Amendments to the Drawings:

REMARKS/ARGUMENTS

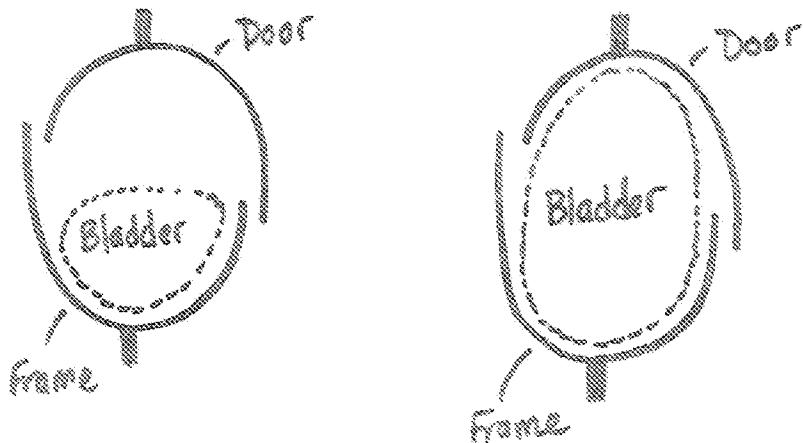
Furthermore, Mena's inflated bladder produces a net inward force, rather than a net outward force, on the door (if a net outward force was produced, then the door would tend to open, since Mena includes a free-floating door and lacks a latching mechanism to hold the door in a closed position absent the inflated bladder). It is true, as the Examiner shows in the attachment to the Office action, that the bladder expands in all directions. Inflation of Mena's bladder, however, pulls the door inward toward the frame in order to lock and seal the door. The following drawings, from Applicants' response dated December 16, 2005, are representative of the door locking mechanism of Mena:

In the above figures, the frame component corresponds to the annular portion 25 of part 18 shown in FIG. 2 of Mena, while the door component corresponds to the annular rim 30 of hatch 14 shown in FIG. 2 of Mena; the door opens to the right in the above figures. In an unlocked state (shown on the left), the bladder is deflated and the door is able to open and close freely (see, for example, Mena, column 3, lines 17-23 regarding closing the door with the bladder deflated, as well as Figures 2 and 3). There is no latching mechanism to hold the door in a closed position. Portions of the door extend beyond (i.e., overlap) corresponding portions of the frame so that the door can only swing to one side of the frame and therefore is not required to (and cannot) move beyond the frame in order to open and close (see, for example, Mena, column 2, lines 52-65). In a locked state (shown on the right), the bladder is inflated and fills the space between the door and the frame so as to pull the door closed (i.e., the net force on the door is to the left) and prevent the door from opening (see, for example, Mena, column 3, lines 28-37).
